*Technical Memorandum: Estimates of Air Quality Impacts of Radon in Landfill Gas
Seaway Site, Areas A, B and C, Tonawanda, New York, USACE, June 22, 2000*

Questions and Answers

Buffalo District
U. S. Army Corps of Engineers

Science Applications International Corporation

FIGURE 1
SCHEMATIC POTENTIAL LAYOUT OF PASSIVE VENTS
SEAWAY LANDFILL

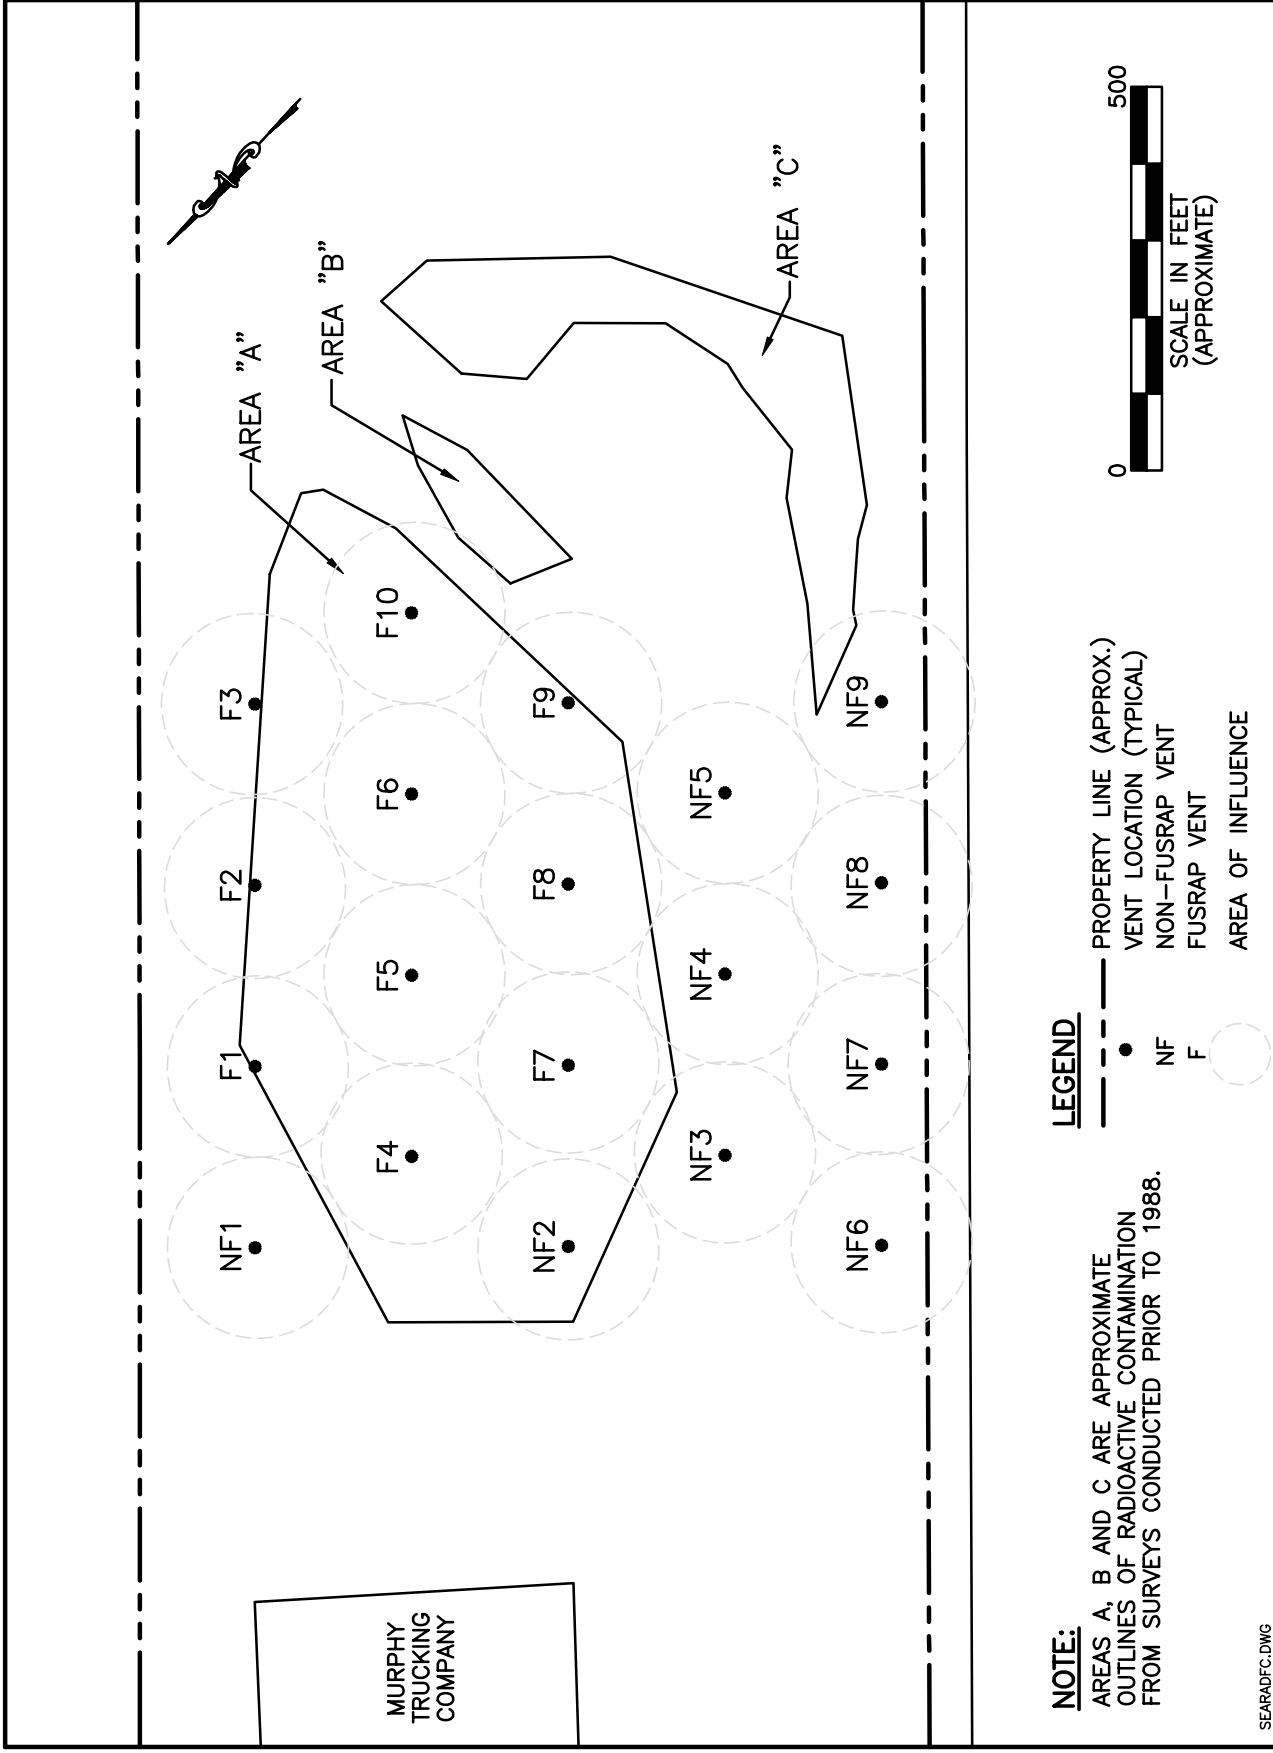
Question: In the TM section on the impacts of passive venting, what are the impacts if venting of the non-FUSRAP area is also considered? What are the impacts if the flare is considered along with passive venting?

To address the question of the impacts from passive venting including the non-FUSRAP area vents, assumptions concerning the layout of the passive vents are required. [It would be unreasonable to assume that all 29 vents (one vent per acre) of the 29 acres of the northern portion of the landfill are co-located and that the impacts of these 29 vents, which would be spread over 29 acres, are additive].

Figure 1 is a schematic layout of vents in and adjacent to Area A of the landfill. The line of vents nearest the eastern property line are about 150 feet (ft)(46 m) from the property line, to reflect the set back from the property line generally maintained in the placement of the existing gas wells in the southern portion of the landfill.

As shown in Figure 1, gas vents are labeled as “F” (FUSRAP area vents) and “NF” (non-FUSRAP area vents). The vents are centered at a spacing of 236 ft. (i.e., to provide about one vent per acre as described in the TM). The other rows of vents, moving westerly from the first line of vents, are placed at intervals of 204 feet (62 m) beyond the easterly line of vents. As indicated in Figure 1, there are 10 vents covering the 9 acres of FUSRAP Area A, and there are 9 non-FUSRAP area vents. The schematic coverage in Figure 1, indicates that the entire northern part of the landfill is equipped with vents to a point from the northern boundary extending southerly about 1000 feet. This generally encompasses all of Area A as well as the non-FUSRAP areas adjacent to Area A.

To estimate the radon impacts at the eastern property line, the SCREEN3 model was used. As described in the TM, the highest impact from a single vent was shown to be in the year 2000 at a height of 16 feet above the ground at the property line when the CAA default values were used. These conditions were assumed in the analysis described below.

SCREEN3 modeling runs were made to estimate impacts at 16 feet above the eastern property line at a unit emission rate of 1g/s. The distances to the property used in the modeling were: 150 ft (46 m), 354 ft (108 m), 558 ft (170 m), 762 ft (232 m), and 966 ft (295 m).

As shown in Table 2, the 0.5 pCi/L radon standard of 40 CFR Part 192, Subpart A, is not exceeded even if the impacts of all 19 vents are considered to be additive.
